Request for Quotation

RFQ NUMBER
DCH10022

DIVISION OF CULTURE & HISTORY
WV INDEPENDENCE HALL
1528 MARKET STREET
WHEELING, WV
26003-3532 304-238-1300

LINE	QUANTITY	UOP	CAT NO	ITEM NUMBER	UNIT PRICE	AMOUNT
----- ADDENDUM NO. 2 -----						
THIS ADDENDUM IS ISSUED TO ADDRESS THE QUESTIONS RECEIVED PRIOR TO THE QUESTION SUBMISSION DEADLINE OF 11/20/2009 AND TO CLARIFY, CHANGE, OR MODIFY THE SPECIFICATIONS.						
THE BID OPENING DATE IS EXTENDED:						
FROM: 12/03/2009						
TO : 12/16/2009						
----- END OF ADDENDUM NO. 2 -----						
0001	1	LS		910-66		
ROOFING WORK AND OTHER RENOVATION						
***** THIS IS THE END OF RFQ DCH10022 ***** TOTAL: _____

DRAWING No.
ADD2SK-1FP

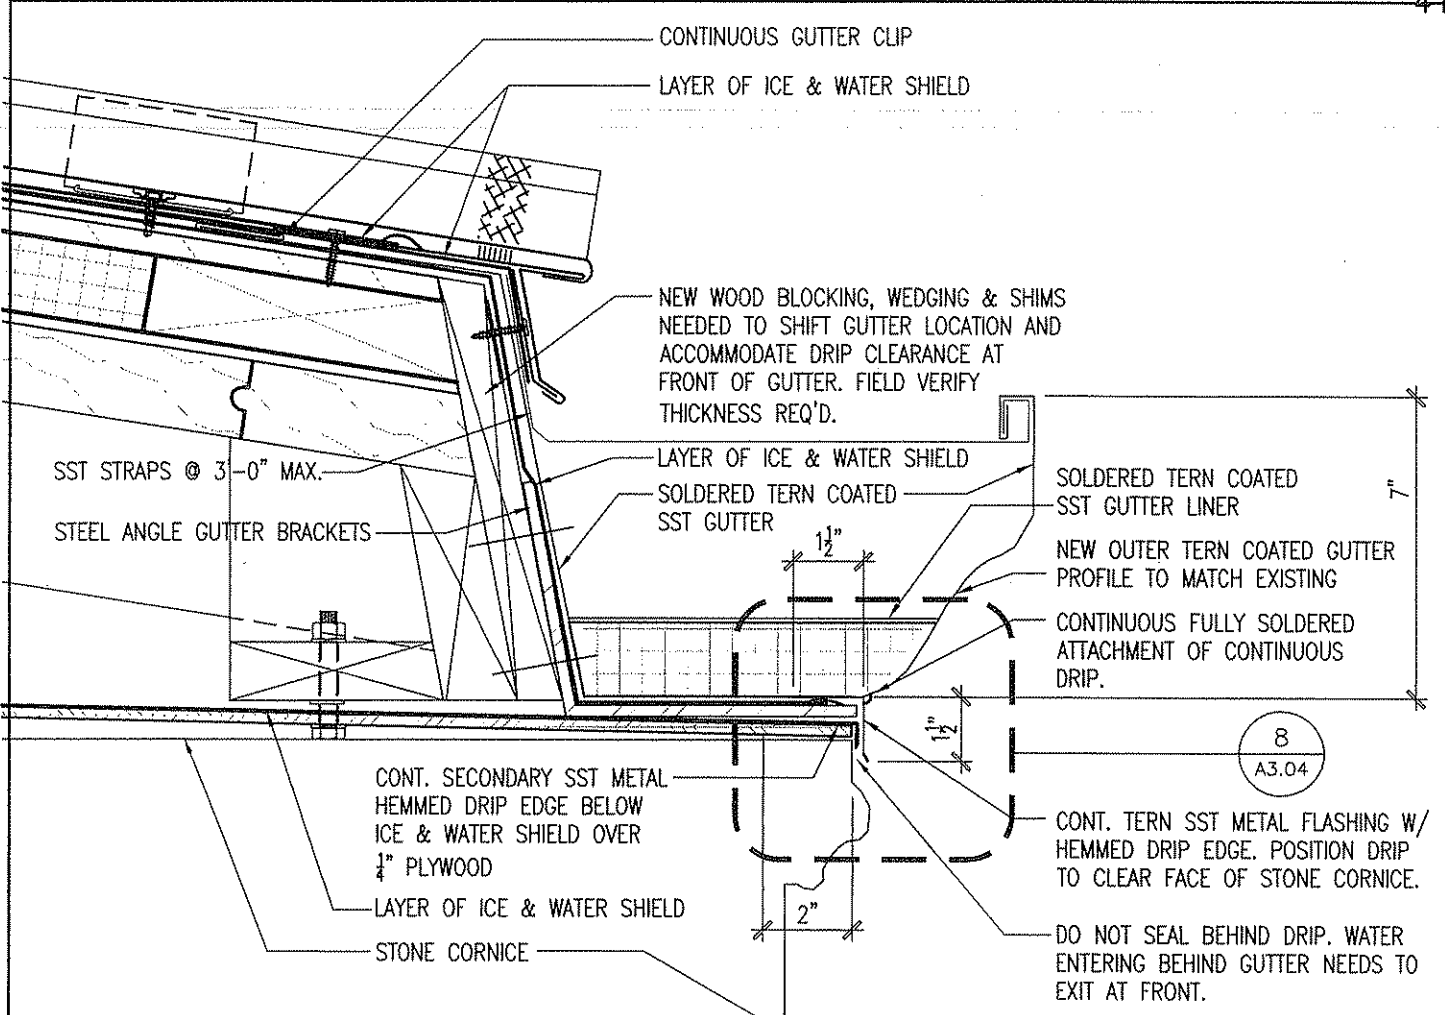
- 1) Add: Add the following note to the drawing: "Refer to Architectural Reflected Ceiling Plans and Details on A4.01 & A4.02 for restoration and repair requirements for existing or new materials, surfaces, construction assemblies and finishes damaged as a result of the installation of the new sprinkler system. All disturbed areas are to be returned to their original or like-new condition at the conclusion of the project."
- 2) Revise: Revise Third Floor Fire Protection Plan layout per attached sketch number: ADD2SK-1FP dated 11-19-09.

REVIEWED	
A	FP M
C	P E
S	
DATE	DWG. REF.
11-23-09	A2.02,A3.04
DRAWING No.	
ADD2SK-2A

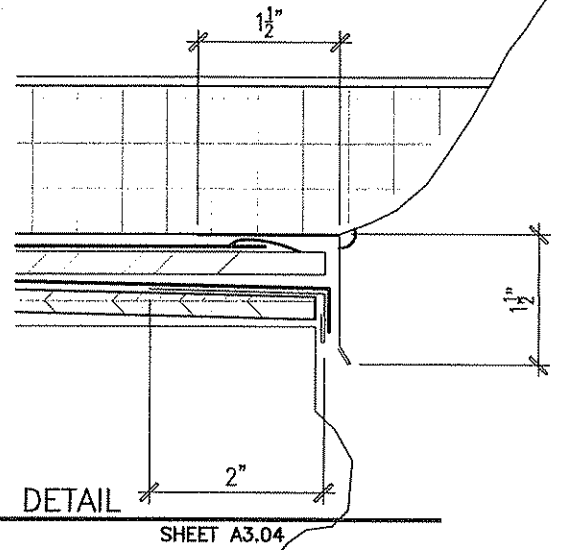
- 1) Delete: Delete note pointing to Window No. 48. Window No. 48 is part of Alternate No. 6.
 2) Add: Add Gutter Detail No. 2/A2.02 to this sheet. See attached Sketch No. ADD2SK-2A dated 11-23-09.

1 BUILDING SECTION

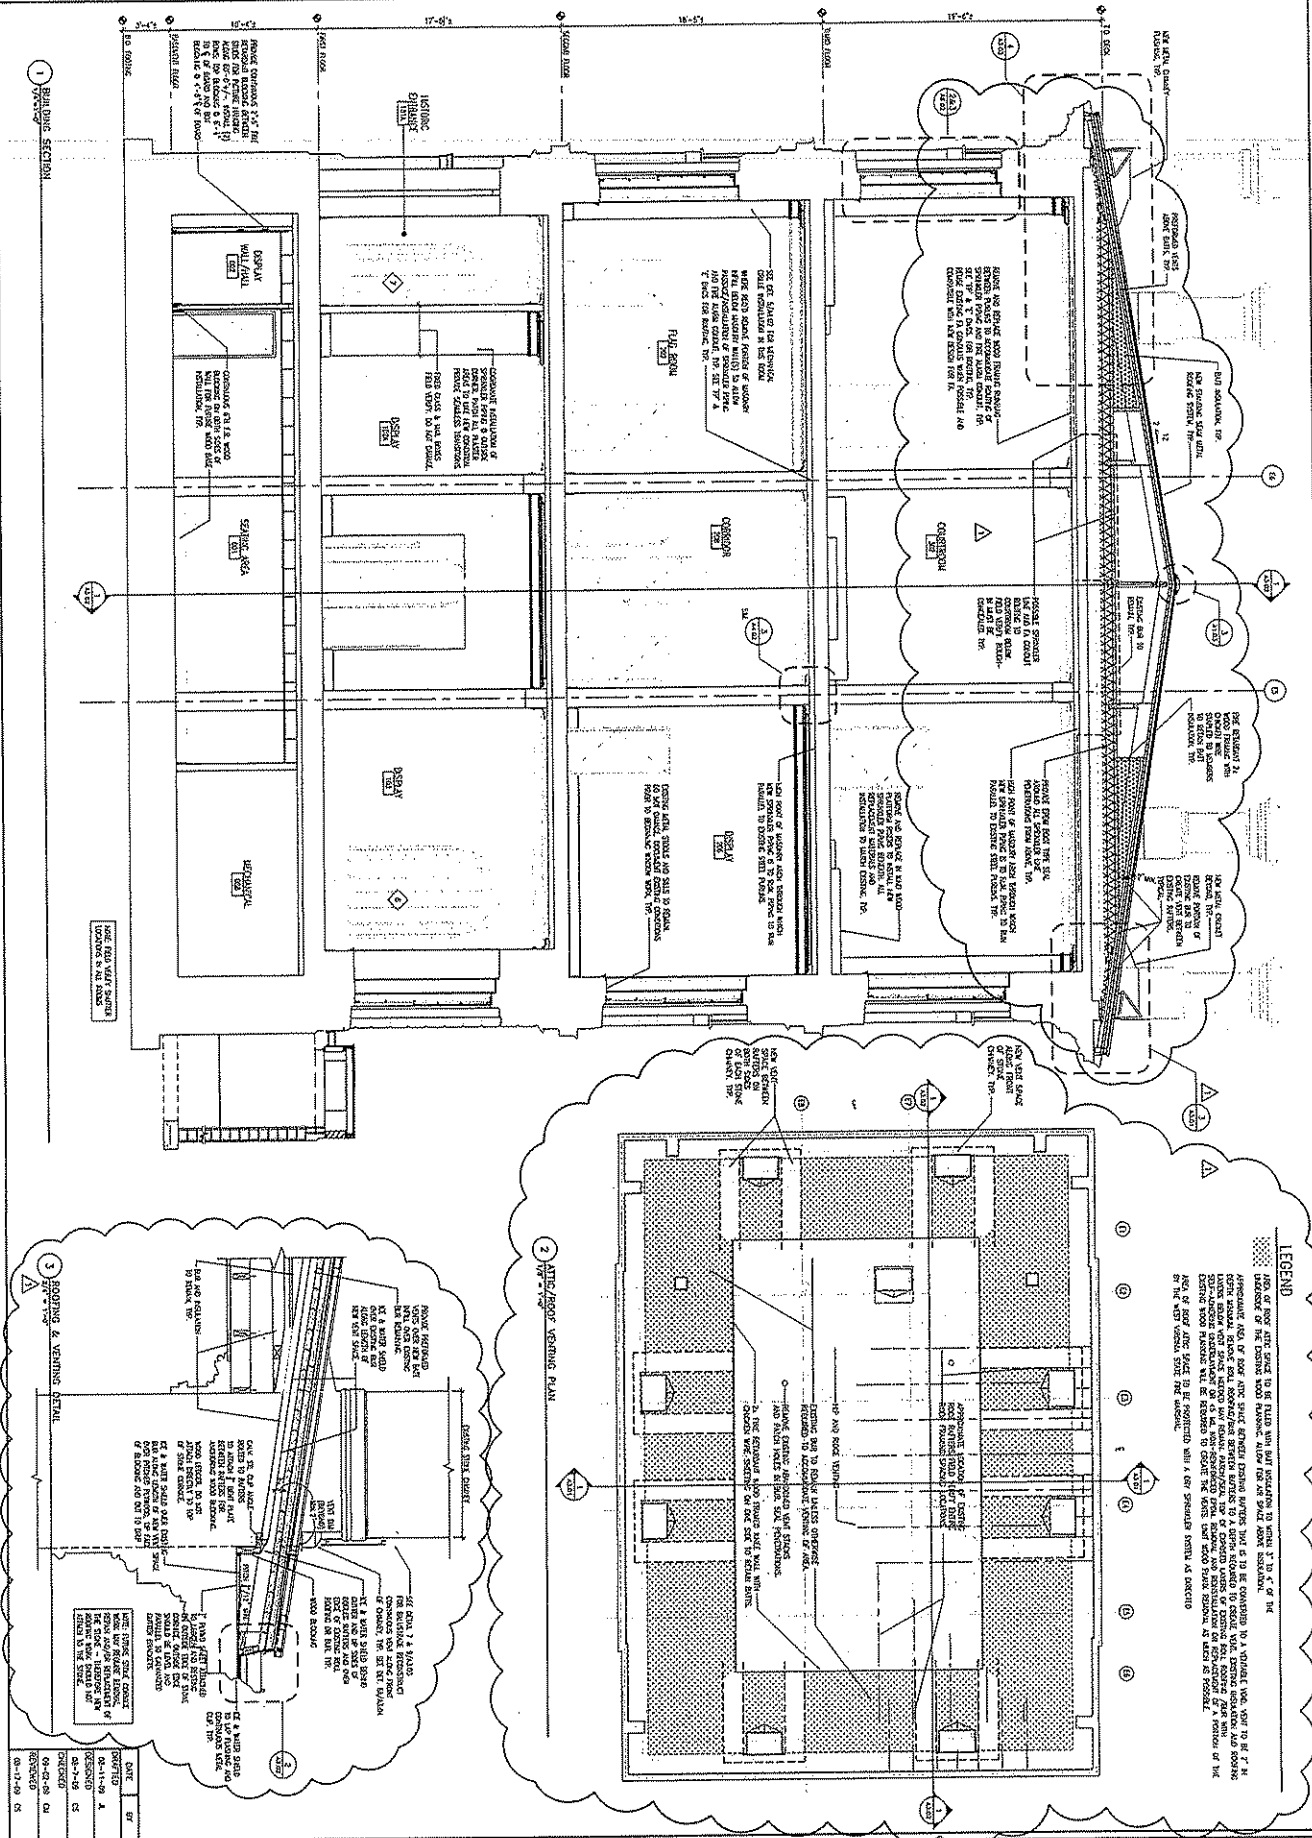
A11 & A12. The Attic sprinkler system has been mandated by the West Virginia State Fire Marshal because the space is accessible. However, a version of the above suggestion has been incorporated into the project. Sheet A3.01 is revised and reissued with this Addendum No. 2. Refer to new plan 2/A3.01 for scope of sprinkling area and area of new batt insulation at the attic level. Provide heads suitable to the revised design that will meet NFPA. Delete heads not suited to sloping condition.

- 1) Reissued: Sheet A3.01 is reissued as part of Addendum No. 2. See changes to Building Section 1/A3.01 at the roof and third floor.

A28. The roofing materials below the batt insulation below the timbers is fully adhered to the existing substrate. BUR is to remain except as required to create the venting. See Sheet A3.01 with drawing revisions. New plan detail 2/A3.01 clarifies the scope of removal of 2”x6” planking that may be needed.

A29. We do not want to remove the dogleg rafters unless they are found to be in poor condition. The insulation is to be removed from between the dogleg rafters. Refer to the new plan detail 2/A3.01. Also refer to new roof detail 3/A3.01. The cost for removal and replacement of the wood dogleg rafters will fall under Unit Cost No. 2. The cost for removal and replacement of the steel dogleg rafters will fall under Unit Cost No. 3.

The ¼" sheathing is not to be attached to the top of the stone cornice. Refer to new Detail 3/A3.01 on reissued Sheet A3.01.
